Corvette Body Rework For Larger Tires

Truck Brake Master Cylinder Cover Leakage

Truck V-8 Engine Exhaust Valve Sticking

Chevy Van Heater Water Shut-Off

Fig. 3—Rework of Brake Master Cylinder Cover Assembly

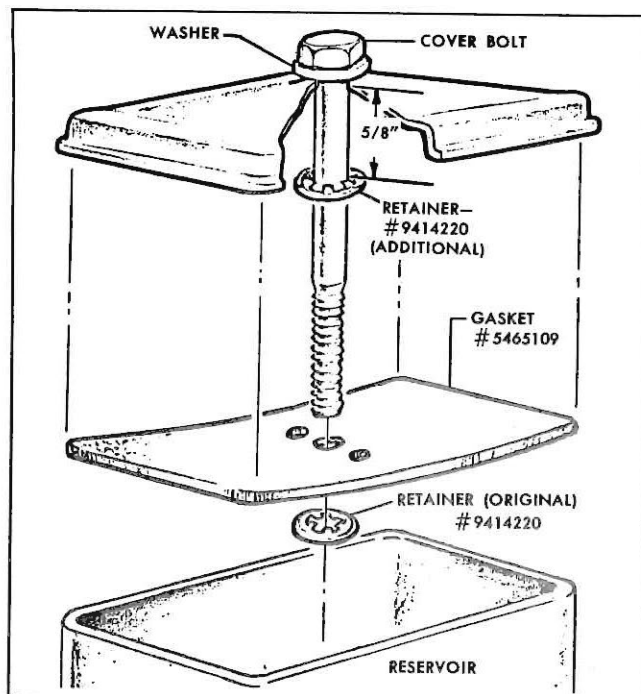
This article provides instructions for a modification that is recommended to avert brake fluid leakage from the rectangular cover used on the brake master cylinder of many 1960-64 trucks. Repeated checking of the brake fluid level has been found to pull the center of the cover gasket upward due to attachment of the gasket retainer to the cover bolt, at the underside of the gasket. Upward movement of the retainer reduces the gasket sealing at the edge and also forms a fluid trap above the gasket, which can result in considerable leakage of fluid out the air vent.

To insure proper gasket positioning is maintained so that brake fluid will not be trapped above the gasket, an additional retainer should be installed on the cover bolt; as described below and illustrated in Figure 3.

The original retainer and gasket can be removed by sliding the cover down and off the bolt. Procure an additional Retainer #9414220 and install on the bolt, positioned $\frac{5}{8}$ inch from the underside of the cover. Install Cover Gasket #5465109 (rubber) against the added retainer and use the original retainer underneath to hold the gasket in place. This will position the center of the gasket about $\frac{1}{8}$ inch below the clamping edge of the cover. Assemble the cover to the master cylinder and torque the cover bolt to approximately 45 in. lb. Do not over-torque as it could cause deflection of the cover and result in fluid leakage.

Fig. 4—Exhaust Valve Guide Rework

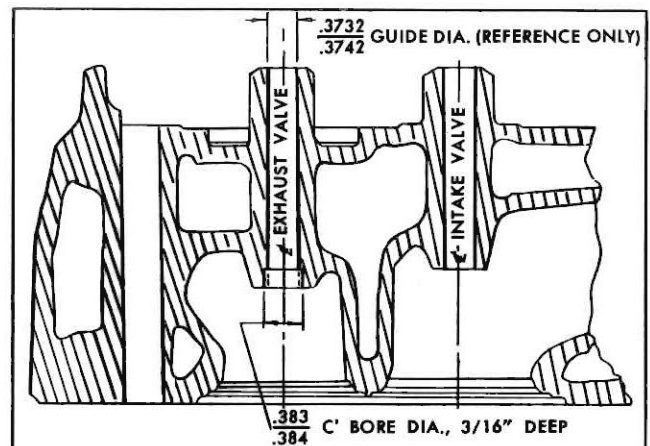
On 348 and 409 cu. in. V-8 truck engines, occurrences of bent or broken push rods can be due to sticking exhaust valves. In those cases where a push rod failure can not be attributed to engine over-speed or other obvious causes, exhaust valve sticking should be suspected.

In many instances when the exhaust valve is removed from the cylinder head in the cold condition, no indication of sticking will be evident. However, valve sticking can be suspected if inspection indicates a carbon build-up in the lower end of the valve guide and the corresponding surface of the valve stem shows carbon streaks or evidence of galling.

If the above exhaust valve problem is experienced on these engines it can be eliminated by counterboring the lower end of the exhaust valve guides .010" oversize, $\frac{3}{16}$ " deep; as shown in Figure 4. The cylinder heads should be cleaned thoroughly after machining.

Figure 5—Heater Water Shut-Off Valve

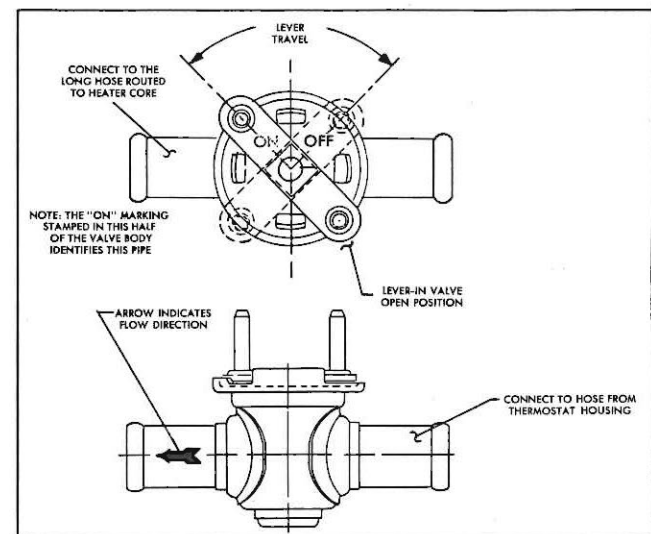
Reports indicate that in many early production Chevy Vans the heater water shut-off valve assembly is incorrectly installed. It is important that this shut-off valve be connected into the heater water inlet hoses with the "ON" marking on the valve body located toward the downstream or heater side of the installation; as shown in Figure 5. If in error,

the valve is connected into the hoses in the reverse direction, it cannot be shut off completely, which would permit hot water flow thru the heater core during warm weather. Check for proper installation of this valve if an owner reports receiving heated air when the valve has been turned off.

NOTE: An arrow stamped into the valve pipe to indicate proper direction of water flow thru the valve, unfortunately is so light on the valves of early manufacture that it will not be detectable on many of these parts.
